Horizon PCB Review: X2A

dwc_ap_lpddr4x_multiply_tsmc16ffc18 : LPDDR4/4x,DDR4 at 4266MT/s

Synopsys SIPI Team

31/03/2020

Signal spacing

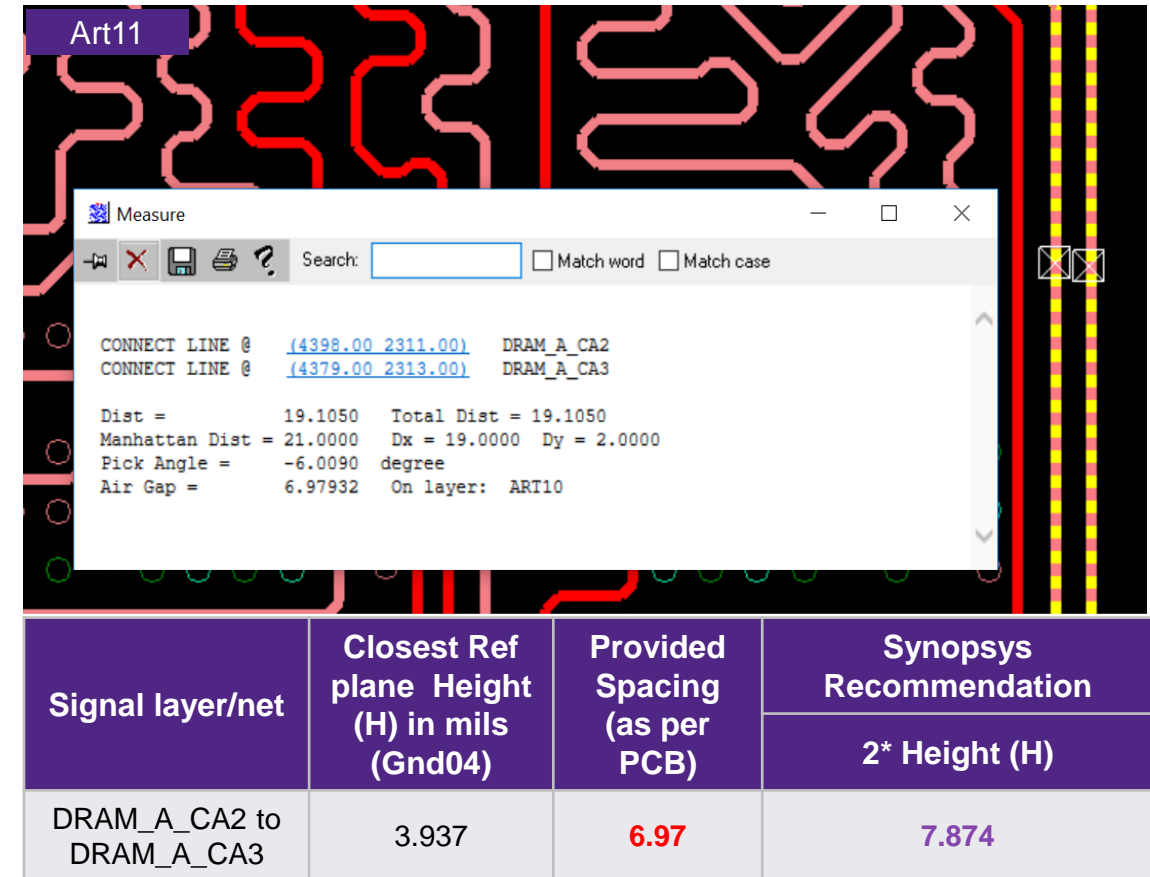
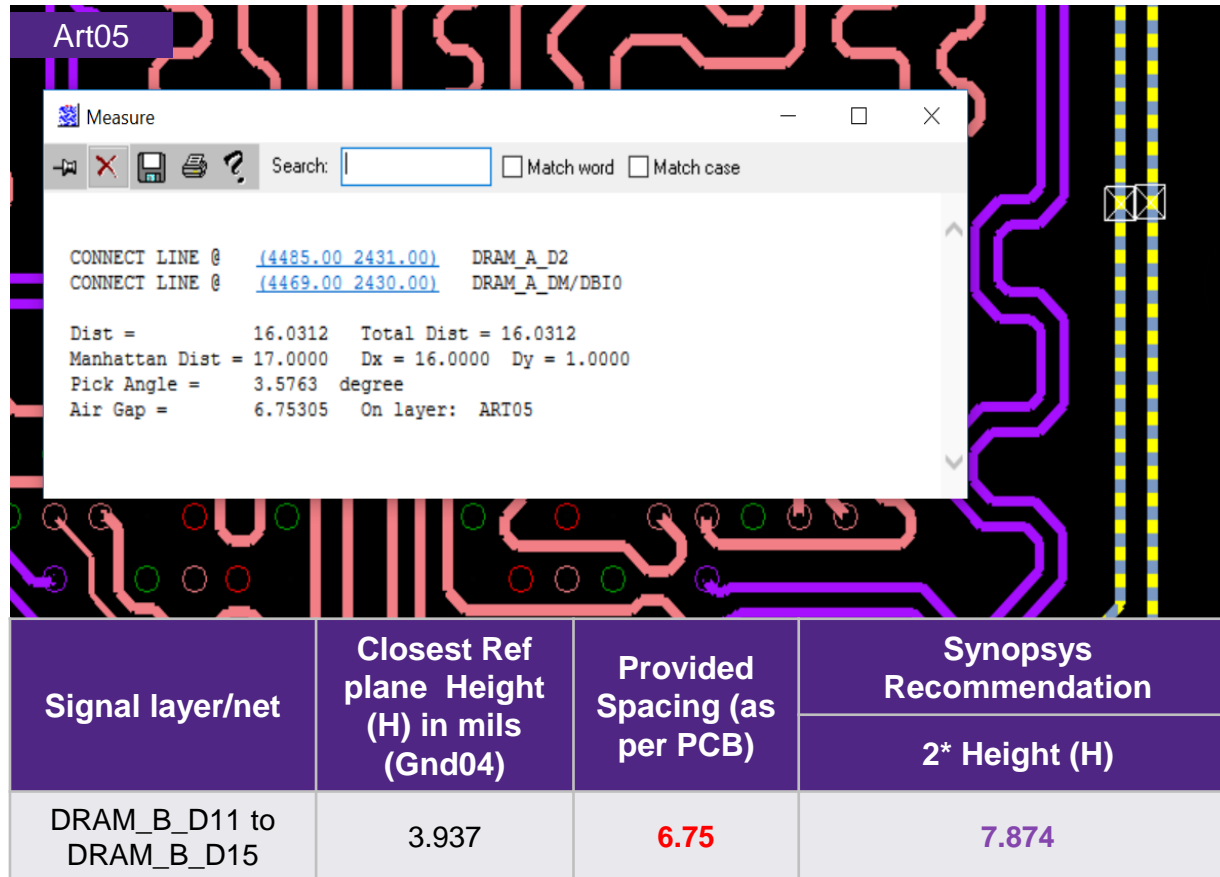
- Guidelines for separation of signals within same group ($\geq 2H$) and from different group ($\geq 3H$) should be followed
- The signal spacing between DQ and DQS within a byte should also be $\geq 3H$
 - Signal Integrity of the signals will be affected due to crosstalk
- H is the distance to closest reference plane
- Based on measured spacing between signals within same group and different groups, Signal Integrity will be affected due to small spacing between traces
- Impact of the crosstalk on the performance of the interface should be confirmed by simulations with extracted model

Spacing is not as per the recommendation

Power vias

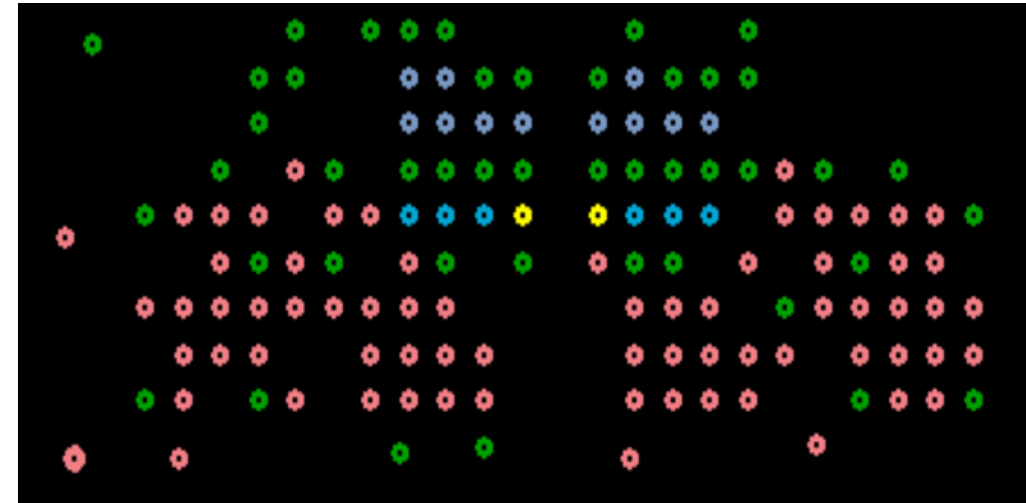
- Via count at PHY side
 - VDDQ_DDR_1V1– 6
 - VDDQLP_DDR_0V6/1V1– 2
 - VDD_DDR_0V8 - 11
- The number of Power vias & the distribution plays a vital role to reduce the loop inductance of the PDN network.
- The sufficiency of the power vias need to quantified through the PDN simulations!
- Add GND vias next to power vias to minimize loop inductance

Reference vias

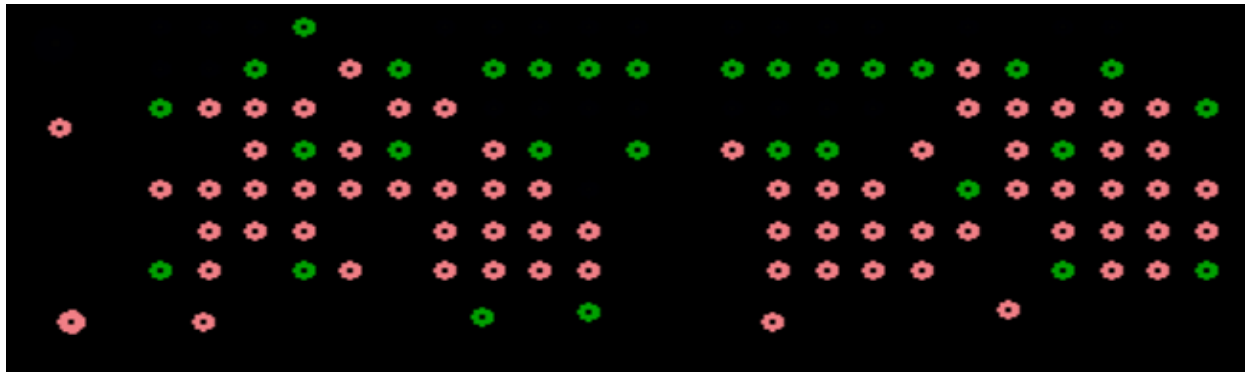
- The GND vias can be more uniformly distributed around the signal vias to have a proper return path and minimize crosstalk.
- Recommended to prioritize DQ Signal to GND Via distribution.
- Need to run simulations to quantify the impact in the current configuration.
